BENDIX RADIO

IMPROVING AVC ACTION IN
RA-1 AIRCRAFT RECEIVER

BULLETIN No. M-115

Date July 12, 1944 ELI

FIGURE 1

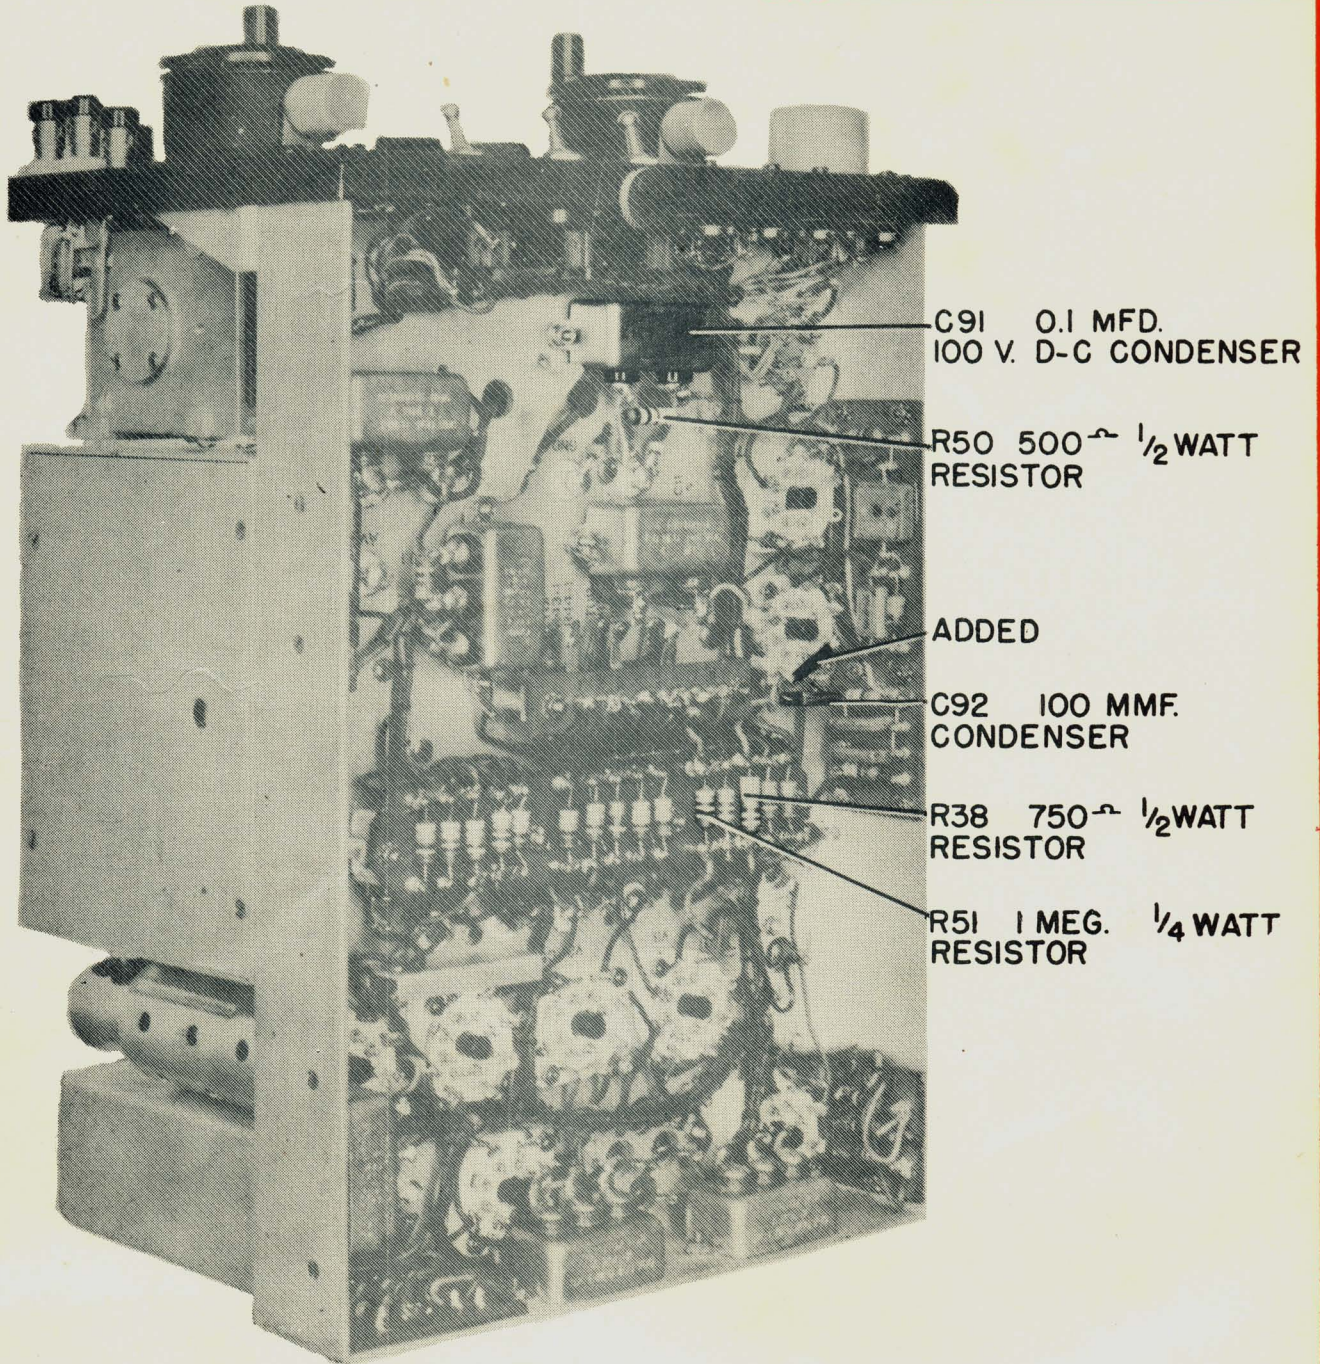
The following changes are to be made on resistor and condenser board assembly AA105053-1. This is the assembly located on the right side of the chassis as shown in Figure 1.

1. Remove ground connection from R24, C65, C67. This is the black wire connected to the top side of R24.
2. Remove ground connection (black wire) from bottom terminal of R37, 1 megohm resistor. (Grid resistor of output tube.)
3. Install jumper wire between bottom terminal of R37 and top terminals of R24, C65, C67.
4. Install C91, 0.1 mfd condenser and R50, 500 ohm resistor as shown

in Figure 1.

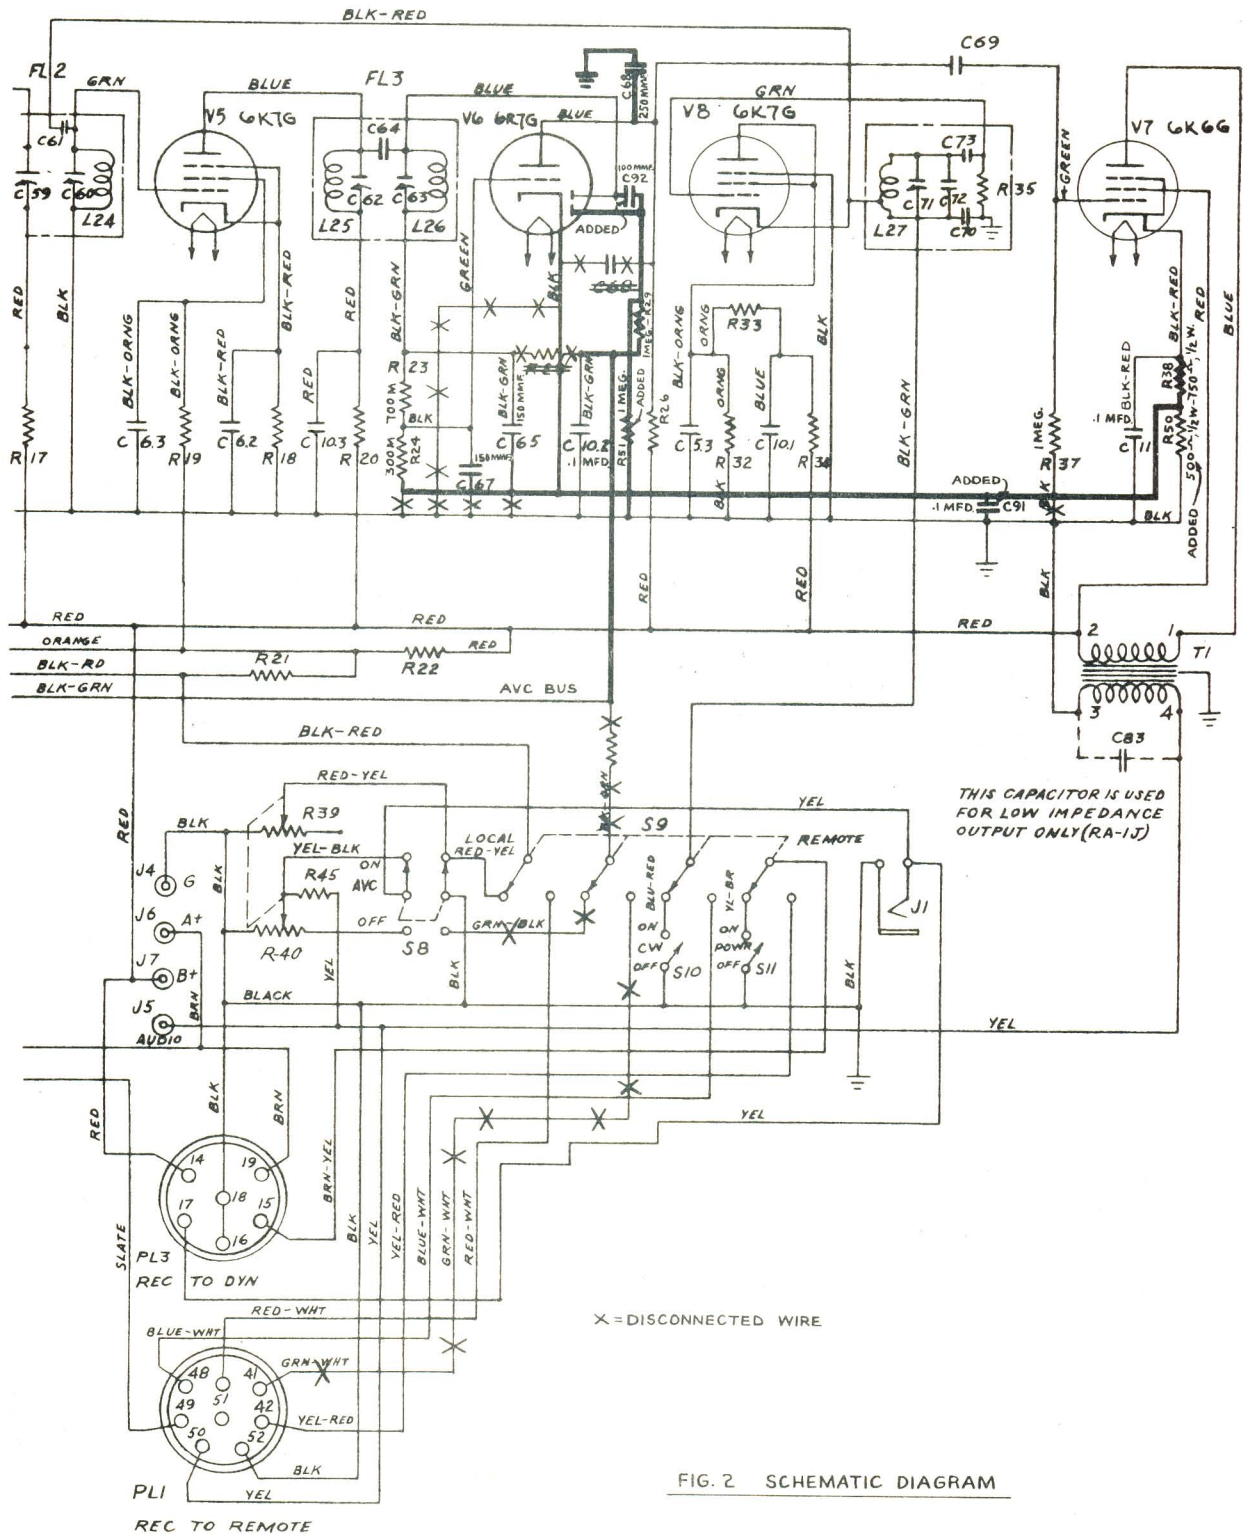
The following changes are to be made on resistor board assembly AA100724-1. This is the assembly located in the center of the chassis.

1. Replace R30 (fourth resistor from end of assembly on right side of chassis) with R51, .1 megohm resistor.
2. Remove jumper wire between R51 and R29 terminals; add ground connection from ground lug near V2 and terminal of R51.
3. Install jumper wire between R51 and R29 terminal facing front of set.
4. Remove wire (BK-W) from R51 and cut it off near the cable. Also remove wire (G-W) from pin #41 of PL-1.
5. Remove R38, 750 ohm resistor from C11 and install it between unused terminals on terminal board between R32 and R29. These are the second and third resistors.

Install 100 mmf condenser, C92, on socket of V6 (6R7G) as shown. Remove jumper wires between pin 1 and 8 between 4 and 5. Remove black and green wire from lug marked DR of FL-3 (third IF transformer) and cut off near cable. Also remove green and black wire from AVC switch and cut off near cable. The AVC switch now controls only the ganged RF and audio potentiometers. In AVC ON position, the audio section functions and in AVC OFF position, the RF section functions to control volume. Delayed AVC is present in either position of the AVC switch.

FIGURE 3

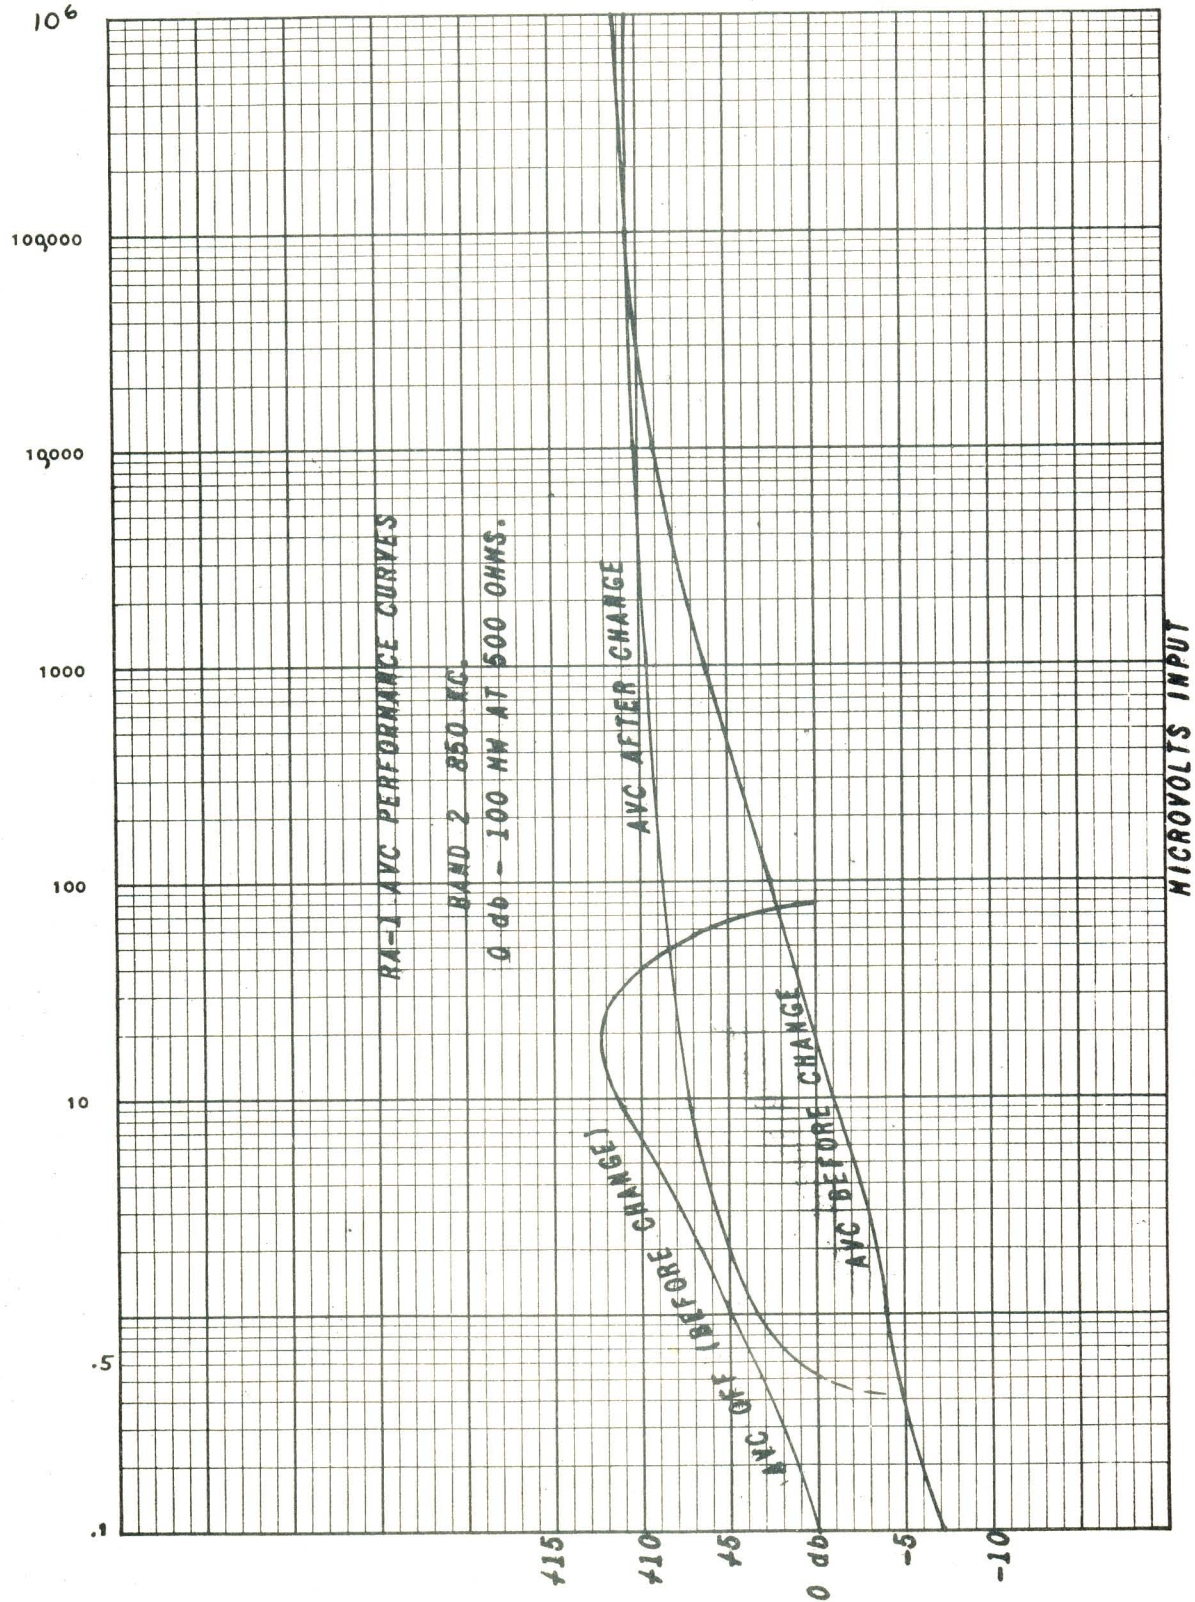
Figure 3 illustrates the AVC control action before and after the changes described herein. These changes have been incorporated in all RA-1 receivers manufactured after May 1, 1944.
